# SERVICE BULLETIN

## REPLACEMENT OF FUEL PUMP FOR ROTAX® ENGINE TYPE 912 (SERIES) SB-912-053UL

### **FOR ROTAX<sup>®</sup> ENGINE TYPE 912 (SERIES) SB-912-053**

Replacement of fuel pumps with part no. 892230, 892232, 892540 through part no. 892542 and Replacement of fuel pumps with part no. 892235, 892236, 892545 through part no. 892546 for ROTAX<sup>®</sup> engine type 912 (Series).

(see Fig.1)

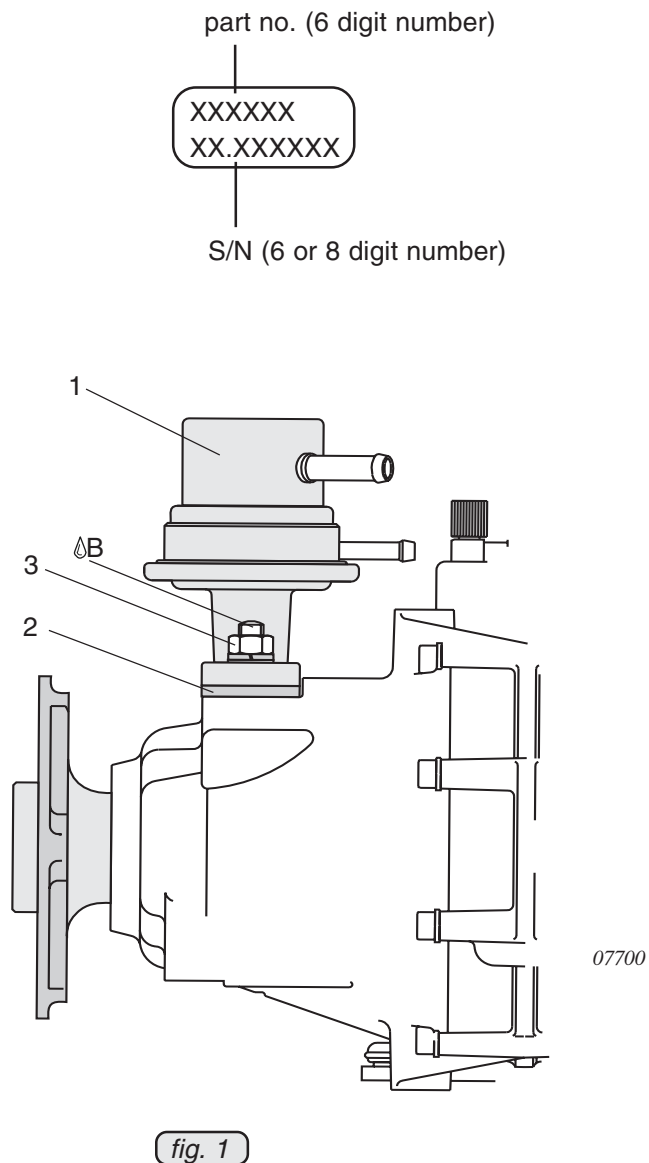
1. Remove fuel pump (1).
2. Gasket (2) replaced by new part.

■ **CAUTION:** Install new gasket supplied with new fuel pump. Do not reuse old gasket.

◆ **NOTE:** On the sealing surfaces of the gearbox housing and the fuel pump no sealing compound has to be used.

3. Install fuel pump.

4. Tighten uniformly hex. nuts (3) with LOCTITE 243. Tightening torque 15 Nm (133 in.lb).

◆ **NOTE:** The additional use of LOCTITE 243 should be applied at each removal/replacement of the fuel pump and/or gasket. A rework of already installed fuel pumps part no. 892542 and 892546 is not necessary.

5. Install fuel line.
